PREVOST

**WARRANTY
BULLETIN**

WB14-47B

DATE :	OCTOBER 2014	SECTION :	04 - Exhaust
EXPIRATION:	OCTOBER 2016		
SUBJECT :	UREA DOSING SYSTEM UPDATE - X AND H SERIES

Figure 3: Exhaust System Components Overview

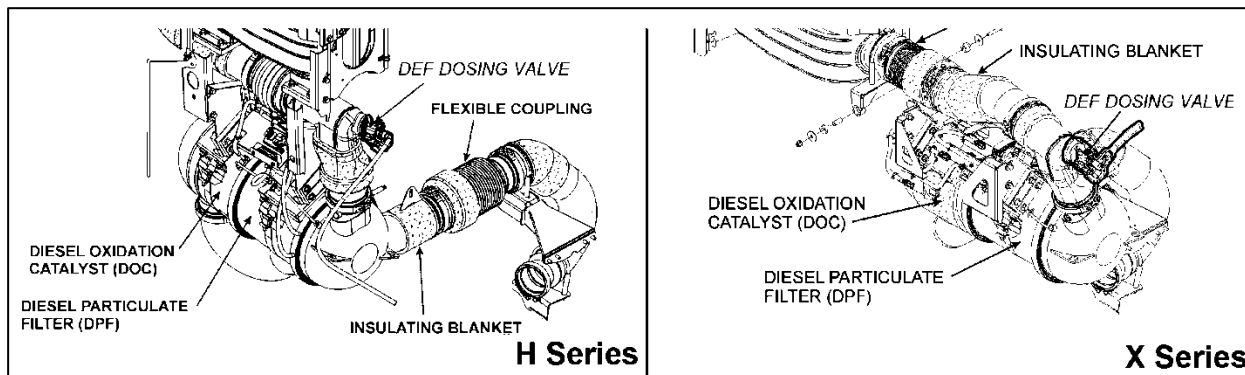
The procedure will guide you through the replacement of the *urea dosing valve*.

Figure 5

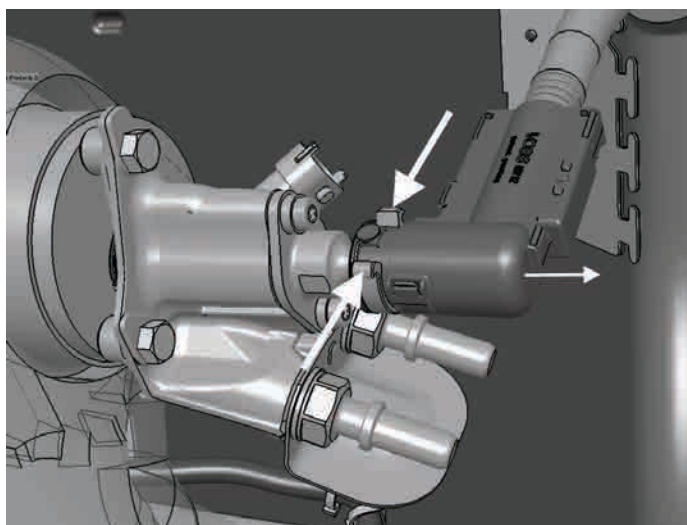
3. Relieve coolant system pressure.
4. Prepare a suitable container to catch any coolant dripping
5. Depress yellow buttons to release quick coupling. (Fig. 5)
6. Mark hose connections to ensure proper reconnection.

Figure 6

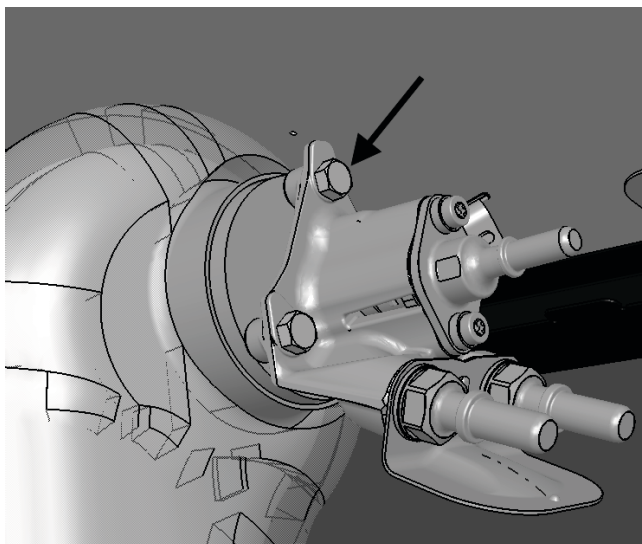
7. Remove electrical connector.
8. *Protect from DEF contamination by taping a plastic bag over the connector.*
9. Disconnect DEF line. (Fig. 6)
